**ZONING AMENDMENT
& SUBDIVISION STAFF REPORT****Date: December 18, 2008**

<u>APPLICANT NAME</u>	911 Dauphin Street, Inc.
<u>SUBDIVISION NAME</u>	The Moors at Springhill Subdivision
<u>LOCATION</u>	North side of Springhill Avenue, 100'± West of the North terminus of Wacker Lane North
<u>CITY COUNCIL DISTRICT</u>	District 7
<u>PRESENT ZONING</u>	R-1, Single-Family Residential District
<u>PROPOSED ZONING</u>	B-1, Buffer Business District
<u>AREA OF PROPERTY</u>	1 Lot / 1.5 ± Acres 5 ± Acres – “Future Development”
<u>CONTEMPLATED USE</u>	Subdivision approval to create 1 lot, and Zoning approval to rezone the lot from R-1, Single-Family Residential, to B-1, Buffer Business, to allow professional offices. It should be noted, however, that any use permitted in the proposed district would be allowed at this location if the zoning is changed. Furthermore, the Planning Commission may consider zoning classifications other than that sought by the applicant for this property.
<u>REASON FOR REZONING</u>	Applicant is requesting rezoning of the lot to allow professional offices. Adjacent property to the East is already commercially zoned.

SITE PLAN

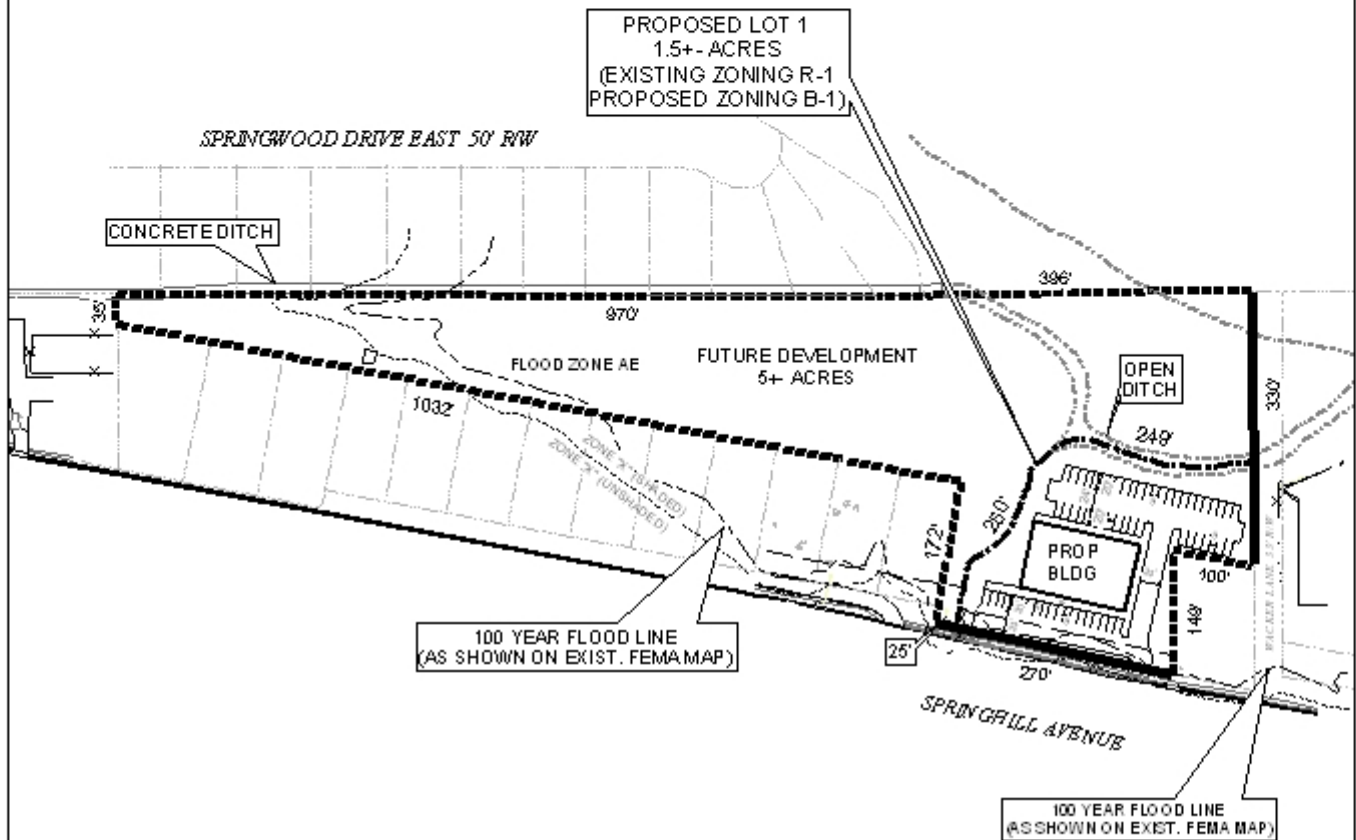
<u>TIME SCHEDULE FOR DEVELOPMENT</u>	Immediately
<u>ENGINEERING COMMENTS</u>	Show Flood Zones and Minimum FFE on plans and plat. No fill allowed within a special flood hazard area without providing compensation or completing a flood study showing that there is no rise for the proposed fill within the special flood hazard area. Must provide drainage easement for any areas receiving public water, size and location of easement to be approved by City Engineer. Must comply with all storm water and flood control ordinances. Any work performed in the right of way will require a right of way permit. It is the responsibility of the applicant to look up the site in the City of Mobile (COM) GIS system and

Driveway number, size, location, and design to be approved by Traffic Engineering and conform to AASHTO standards. Minimum driveway width is twenty-four feet with a twenty foot radius. Changes should be made to accommodate these standards.

on the South side of Spring Hill Avenue, proposed Lot 1 should be limited to one (1) curb-cut, to align with the larger existing curb-cut across the street, with the size, design and exact location to be approved by Traffic Engineering and conform to AASHTO standards. It should be pointed out that there is a note on the Zoning site plan and Subdivision preliminary plat that states that the proposed lot is limited to one curb-cut, yet the site plan depicts two curb-cuts.

The plat should be revised to depict dedication of right-of-way along Wacker Lane sufficient to provide 25-feet, as measured from the centerline.
